**CITY OF EL PASO, TEXAS
AGENDA ITEM DEPARTMENT HEAD'S SUMMARY FORM**

An Ordinance granting Special Permit No. PZST14-00032, to allow for a ground-mounted 55' Personal Wireless Service Facility on the property described as Lot 1, Block 1, Delta Subdivision, 314 S. Glenwood Street, City of El Paso, El Paso County, Texas, Pursuant to Section 20.10.455 of El Paso City Code. The penalty being as provided in Chapter 20.24 of the El Paso City Code. Subject Property: 314 S. Glenwood Street. Property Owner: El Divino Salvadore Presbyterian Church, Inc. PZST14-00032 (**District 8**)

City of El Paso – City Plan Commission Staff Report

Case No: PZST14-00032
Application Type: Special Permit and Detailed Site Development Plan
CPC Hearing Date: December 18, 2014
Staff Planner: Andrew Salloum, (915) 212-1613, salloumam@elpasotexas.gov

SHEET TITLE
OVERALL SITE PLAN

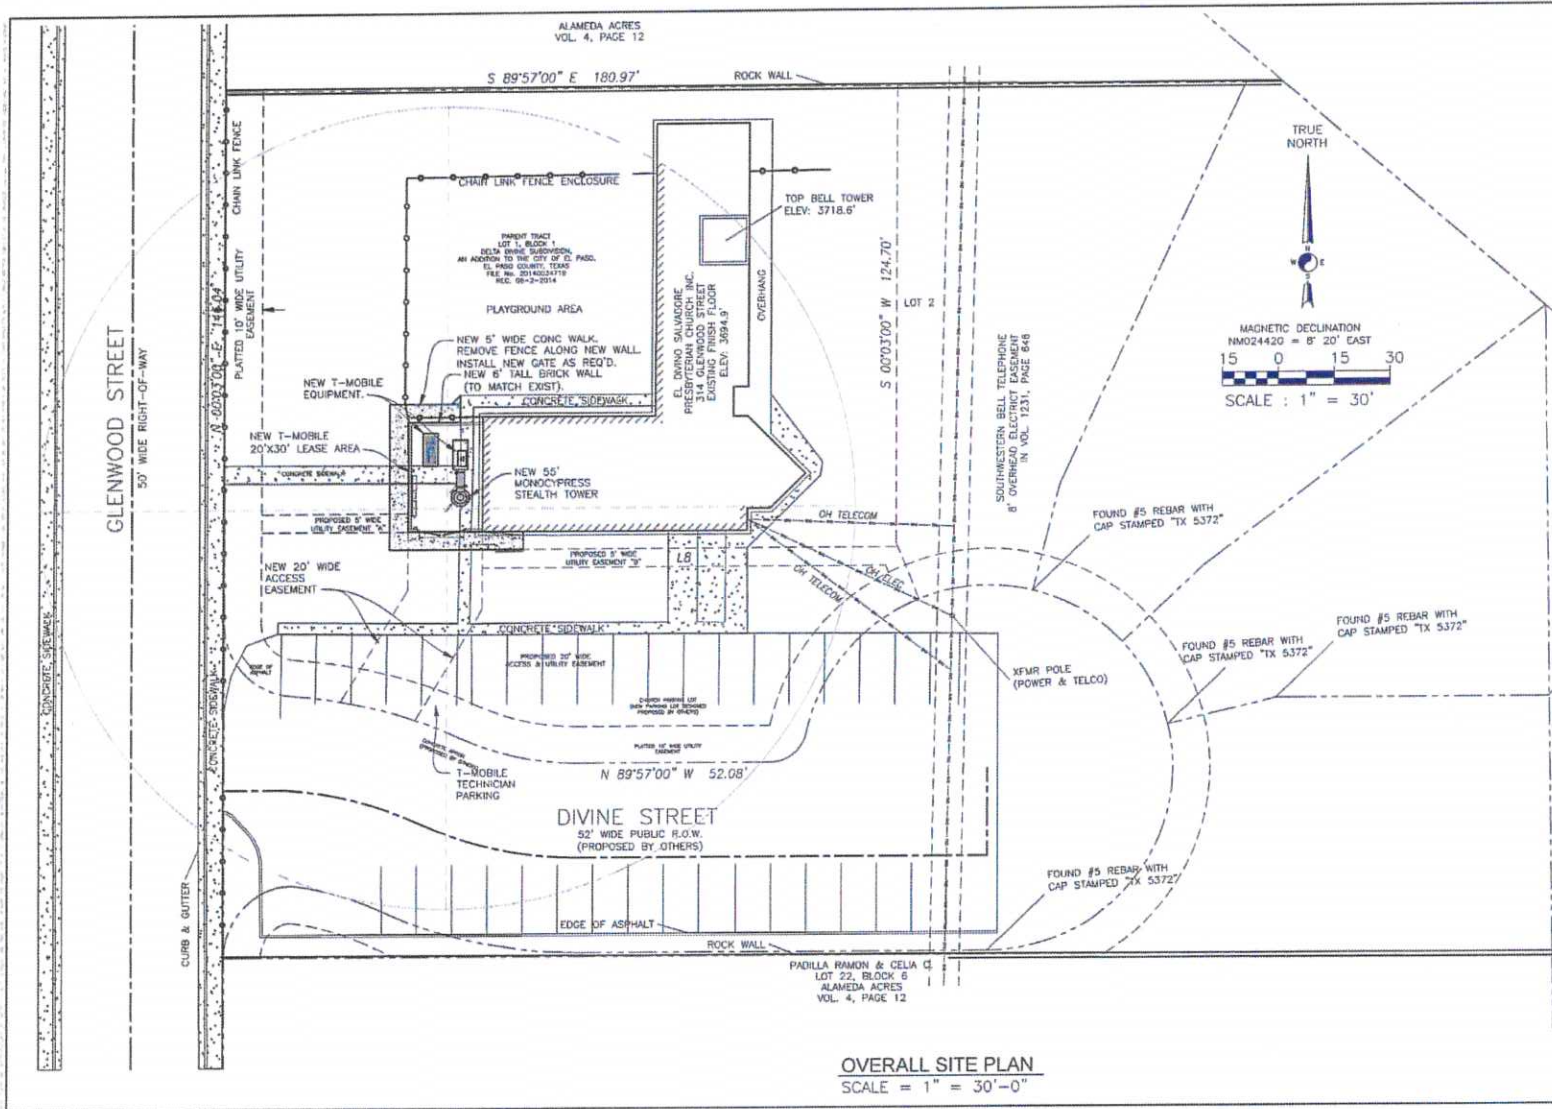
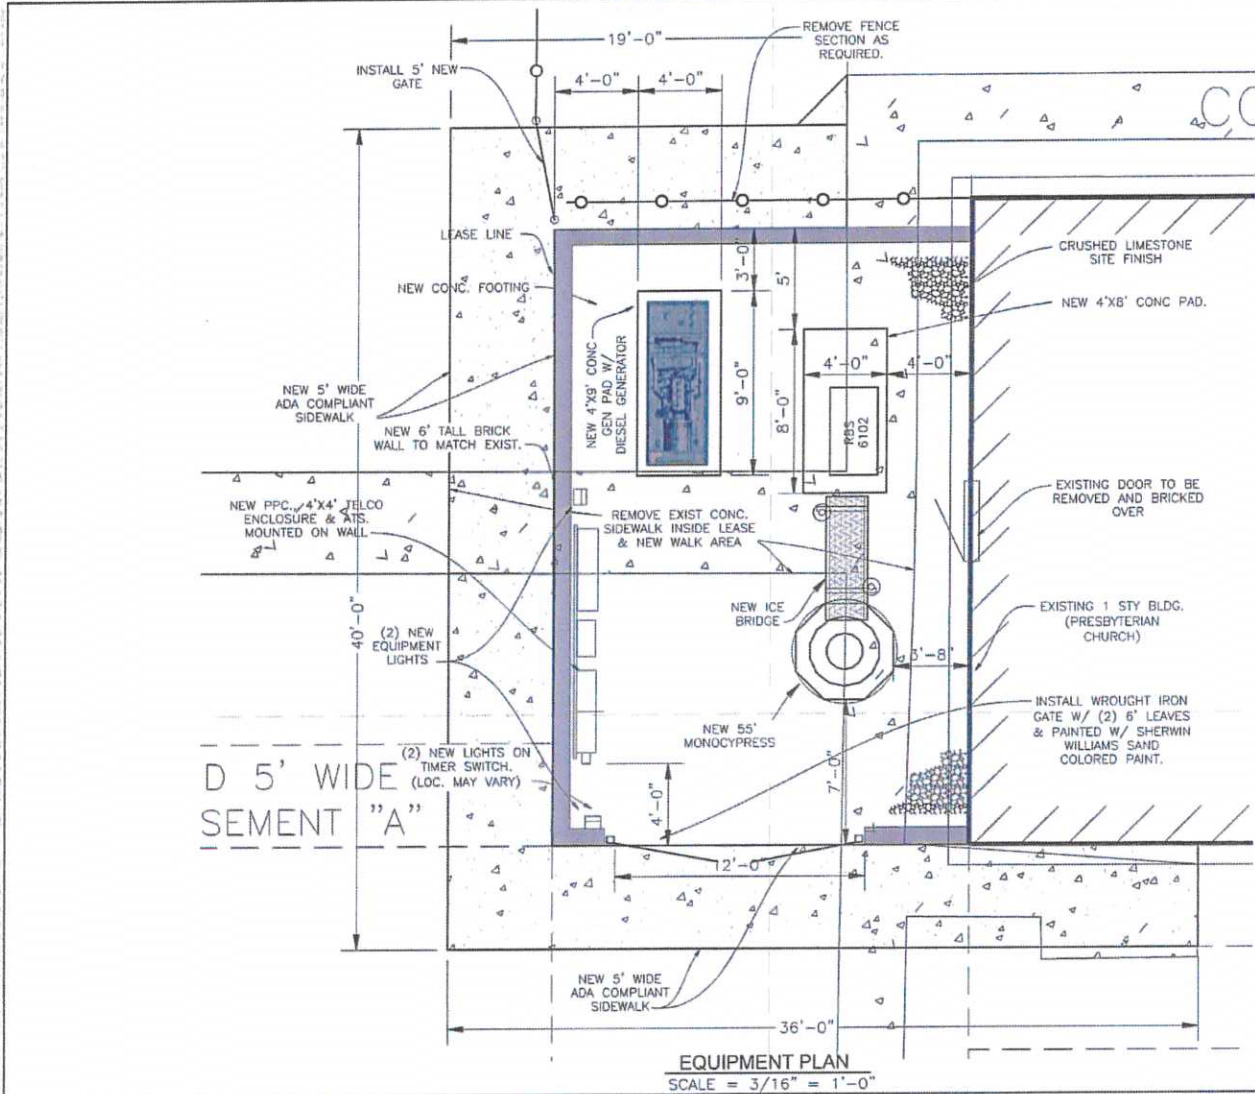
There is an existing 8-inch diameter water main along Glenwood St. approximately 4 feet west of the subject west property line. This main is available for service.

EPWU records indicate an active 1-inch water meter serving the subject property. The service address for this meter is 314 S. Glenwood St. and is located off Delta Dr. This water meter serving Lot 1 will have to be relocated to Glenwood St. The Owner/Developer is responsible for the costs of relocation.

There is an existing 8-inch diameter sanitary sewer main along Glenwood St. The main is located approximately 19 feet west of the Glenwood St. right of way line. This sanitary sewer main is available for service. The sewer main is only 4.5 feet deep.
